Monticello Extended Power Uprate (USNRC TAC MD8398):
Acceptance Review Supplemental Information Package 3

Non-Proprietary Version of Enclosure 1,
Mechanical and Civil Engineering Branch
Questions and Responses

Group 6

Mechanical and Civil Engineering Branch
Question 3 and Response 3

Figure 6.7a: Eigenmode at 25.7 Hz. Outer hood mode.

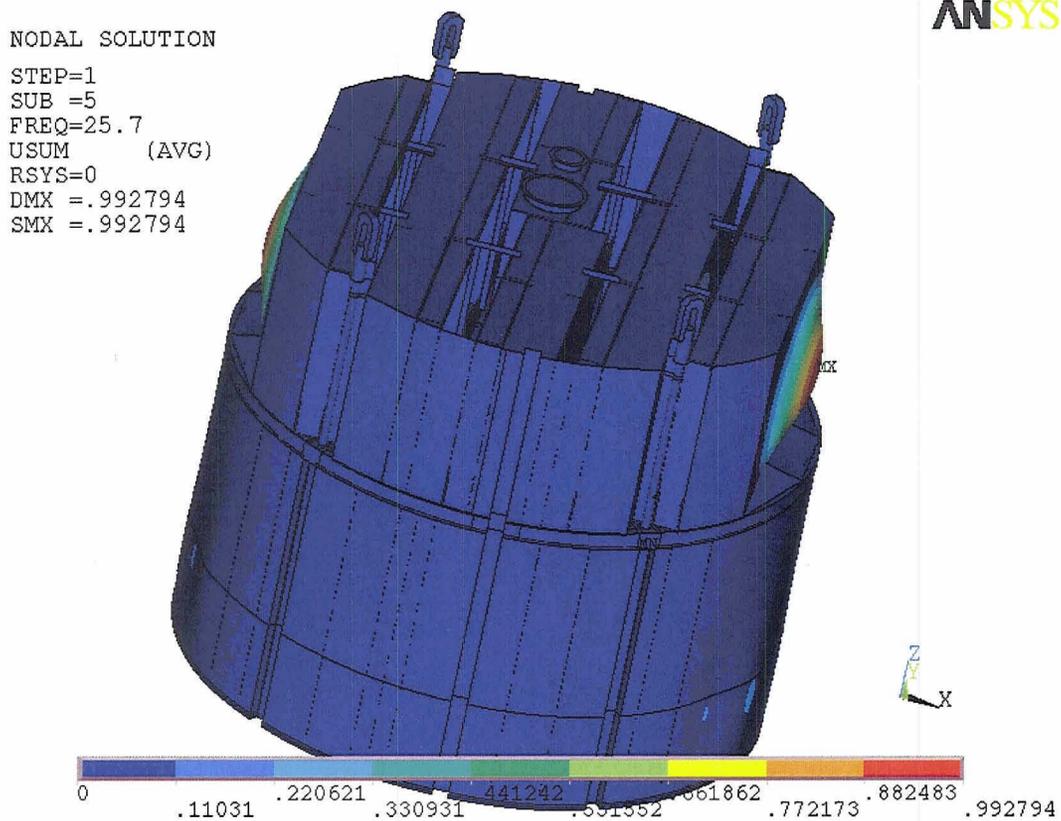
6.7: *The application does not include information on the mode shapes of the dryer at and near peak frequencies including 25-26 Hz, 154 Hz, and 162 Hz.*

Please refer to Figures 6.7a through 6.7h of this response for this information.

There are five eigenmodes in the range 25-26 Hz. These eigenmodes involve primarily hoods of the steam dryer as indicated on Figure 6.7a and Figure 6.7b. Additionally, there are modes with coupled motion of the hoods and the skirt, as shown on Figure 6.7c.

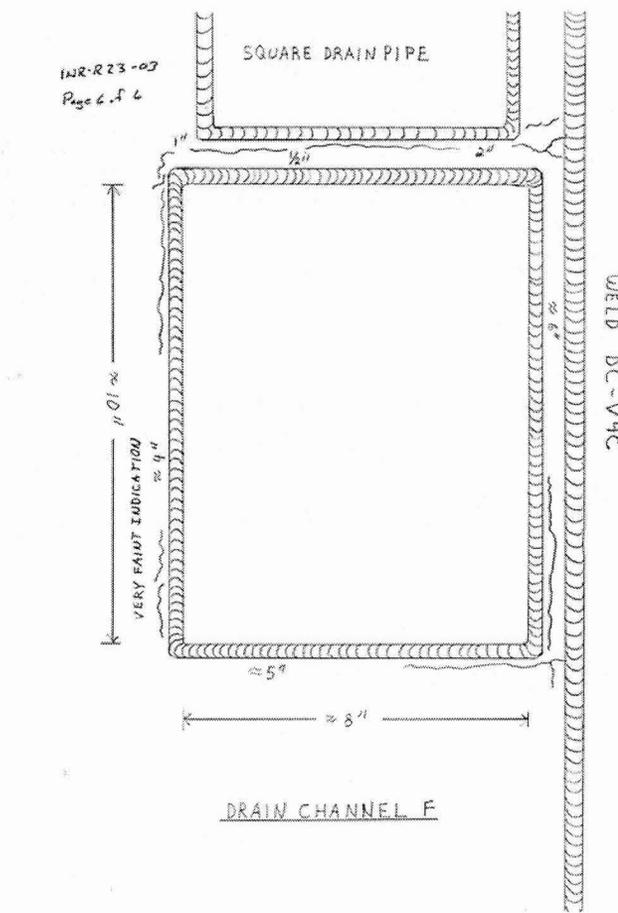
6.3: The application does not include information on operating history, location of flaws and cracks that currently exist in the steam dryer, and the root causes for such cracks. Furthermore, the application does not address the effect of EPU on the integrity of the dryer in the presence of existing cracks.

The indications on the Monticello steam dryer are at the top of the vertical weld behind the lifting rods. Figures 5-1 and 5-3 through 5-8 of BWRVIP-139 provide weld identification numbers that were used to identify the steam dryer welds.

The stresses due to flow induced vibration (FIV) loads were qualitatively reviewed using information provided in BWRVIP-139. Typical finite element analysis (FEA) results of a square hood steam dryer design are presented in BWRVIP 139. From the FEA results, the stresses at the location of the indications due to FIV loads appear to be relatively low. Figures 4-8 and 4-9 of BWRVIP-139 show stress plots for the vertical dryer plates of a square hood steam dryer design. A review of these plots shows that the stresses due to FIV are relatively low at the location of the indications on welds V3 90°, V10 90°, and V10 270°. This is further supported by FEA results for the Monticello steam dryer as shown in Extended Power Uprate (EPU) License Amendment Request (LAR), Enclosure 11, Figures 13a, 13c, 14a, 14b, 14c and 14d. Monticello current licensed thermal power (CLTP) alternating stresses at the indication locations are below 500 psi and peak stresses are on the order of 1000 psi. These values are well within allowable stress values. Thus, high residual stresses due to fabrication were most likely the cause of the indications along with some stress concentration, rather than the magnitude of the FIV loads. This conclusion is also reinforced by the extent of cracking. The lengths of the indications are relatively short and would expect to be significantly longer at this time if significant FIV loads were present. Sufficient time has passed such that enough cycles would have occurred to cause initiation and significant crack growth if the FIV loading was significant.

Based on available information, the Monticello steam dryer indications at Welds V3 90°, V10 90°, and V10 270° were fabricated using the same welding sequence resulting in elevated residual stresses. After the crack initiated, the residual stress would be reduced as the crack extended and the crack growth would slow, limiting the length of the indication. Since loads in this area based on the Monticello FEA are low, crack growth is not expected under EPU conditions.
